Optimization Review
Groveland Wells Numbers 1 and 2 Superfund Site
Town of Groveland, Essex County, Massachusetts

OPTIMIZATION REVIEW

Report of the Optimization Review
Site Visit Conducted at the Groveland Wells Numbers 1 and 2 Superfund Site on
February 29, 2012

FINAL REPORT
January 7, 2013

Figure 6-1. Flow Chart Illustrating Suggested Decision Framework

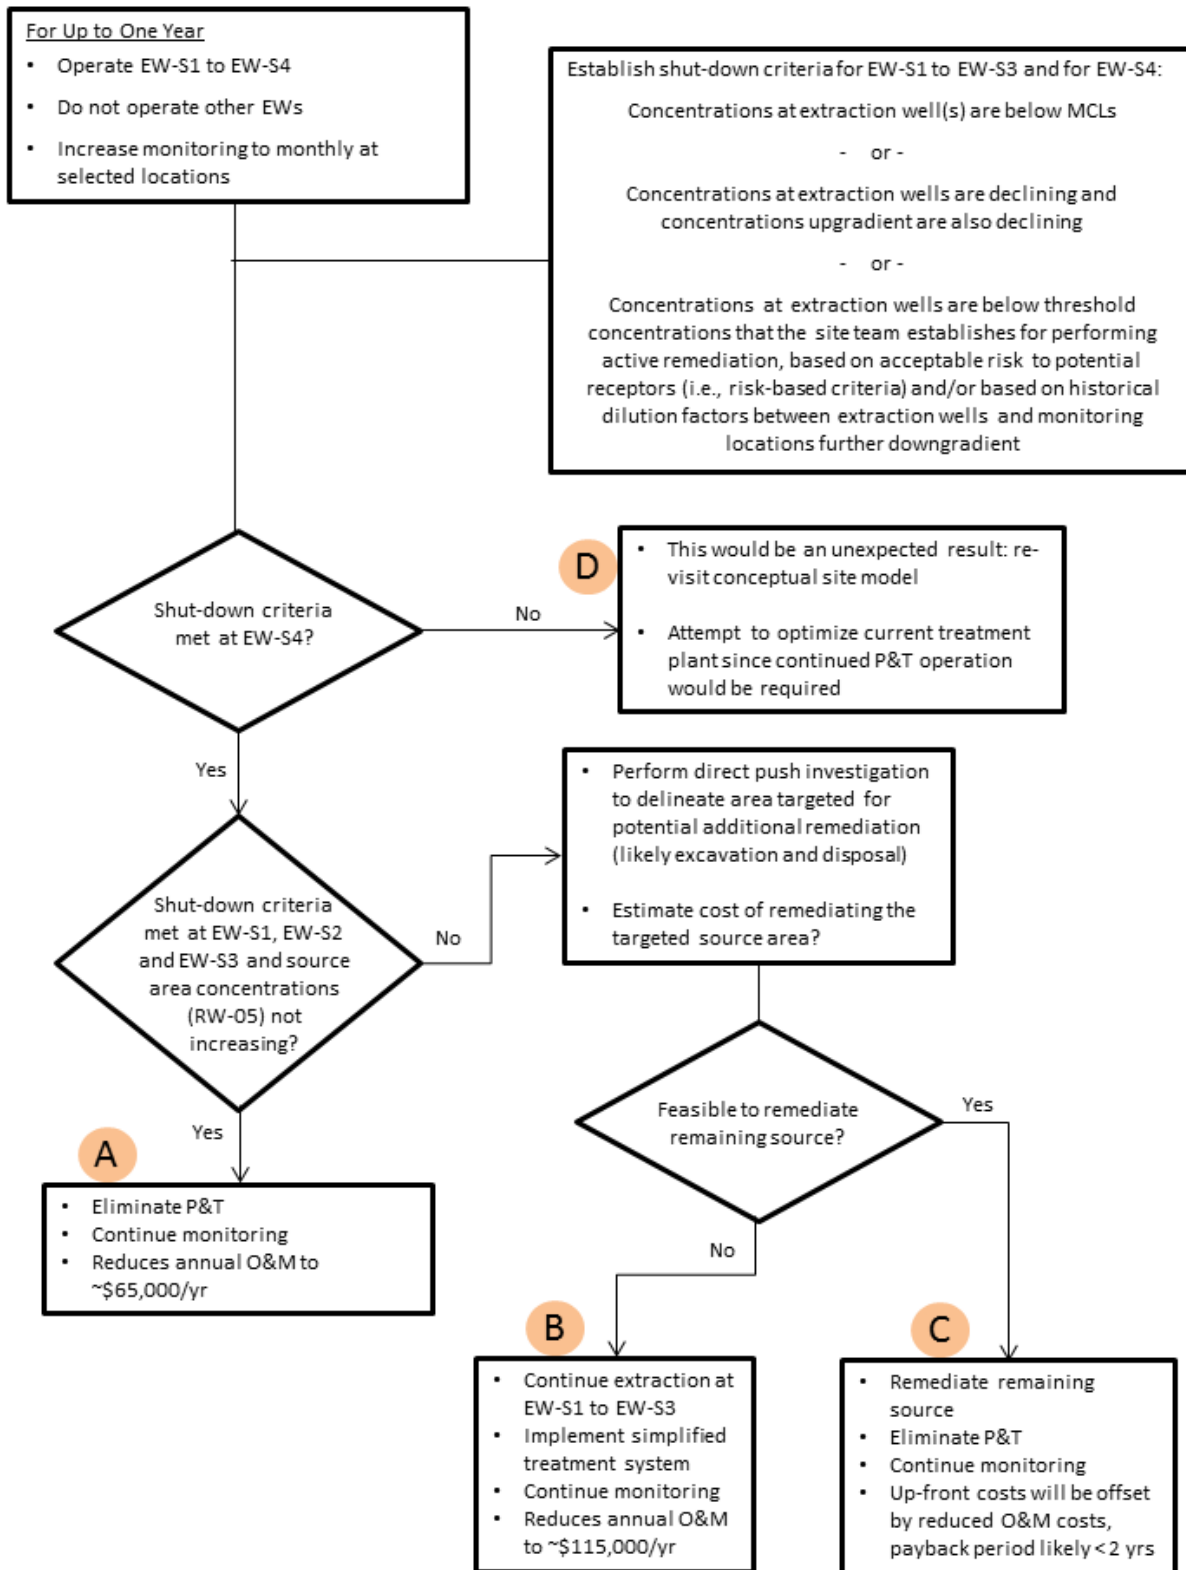
With respect to the recommendation described in Section 6.1.1, the site team could consider an alternative approach in which extraction wells EW-S1 through EW-S3 are not returned to operating status during the initial monitoring period. EW-S4 would continue to operate, and the GTWF would still be needed. This approach might entirely eliminate the re-start of those three extraction wells if the shutdown criteria for EW-S1 through EW-S3 and EW-S4 can all be met, resulting in Outcome “A” on Figure 6-1. However, there is additional risk in pursuing this alternative because there is a possibility that the shutdown criterion for EW-S4 (see Section 6.4.1) might not be met in the absence of extraction at EW-S1 through EW-S3. If that occurred, it would eliminate the potential to achieve outcomes “A,” “B” or “C” on Figure 6-1 in the short-term (i.e., it would delay potential elimination or substantial streamlining of the current GWTF), and would complicate subsequent decisions. The decision framework illustrated on Figure 6-1 allows for a more straightforward decision-making process.

- *Outcome “A” on Figure 6-1.* A likely potential outcome is that P&T operations at this site will be terminated within 1 year (and perhaps much less than 1 year). If that occurs, the current cost of \$345,600 per year would likely be reduced to approximately \$65,000 per year (assuming \$25,000 per year for project management and \$40,000 per year groundwater monitoring). Thus, cost would be reduced by approximately \$280,000 per year for this scenario versus the current P&T system.

- *Outcome “B” on Figure 6-1.* Another potential outcome is that P&T extraction can be limited to source area wells EW-S1 through EW-S3 within 1 year, and the associated flow rate would allow for a simpler treatment approach. The current cost of \$345,600 per year would likely be reduced to approximately \$115,000 per year (assuming \$65,000 per year for the scenario with no P&T described above, plus an additional \$50,000 per year associated with management and operation of a smaller P&T system as detailed in Section 6.4.2). Thus, cost would be reduced by approximately \$230,000 per year for this scenario versus the current P&T system. It is expected that treatment plant modifications for this scenario would require up-front costs of approximately \$50,000, with payback achieved in much less than 1 year.

- *Outcome “C” on Figure 6-1.* Another potential outcome is that additional source area remediation (likely to consist of excavation and disposal) may be required in a targeted area to enable the complete shutdown of P&T operations. Based on the size of the targeted area, the up-front costs might range from less than \$100,000 to \$500,000 or more, as discussed in Section 6.4.2. These up-front costs would be offset by annual savings of approximately \$280,000 per year that would result from complete termination of P&T operations (as discussed in Outcome “A” above). Thus, the payback period might range from less than 1 year to as much as several years for this scenario.

- *Outcome “D” on Figure 6-1.* An unexpected outcome would be that downgradient extraction well EW-S4 needs to continue operating because the remaining source area is sufficiently strong and the capture provided by EW-S1 through EW-S3 is not sufficient. If this outcome occurs after the first year, it would then be appropriate to re-visit the CSM, and to optimize the current GWTF since continued P&T operation would be required.

A potential approach for addressing these shutdown criteria is indicated on Figure 6-1. However, determining the shutdown criteria for the extraction wells is not solely a technical decision, thus the optimization review team cannot provide more specific recommendations or opinions. If there is concern or uncertainty about selecting shutdown criteria, the EPA and MassDEP may decide to devise a contingency plan that allows extraction well operation to resume after shutdown if concentrations at pre-determined monitoring points increase above a pre-determined action level. The optimization review team believes that the primary effort involved in implementing this recommendation involves meetings between the EPA and MassDEP. Limited contractor support for these meetings might cost up to \$10,000.
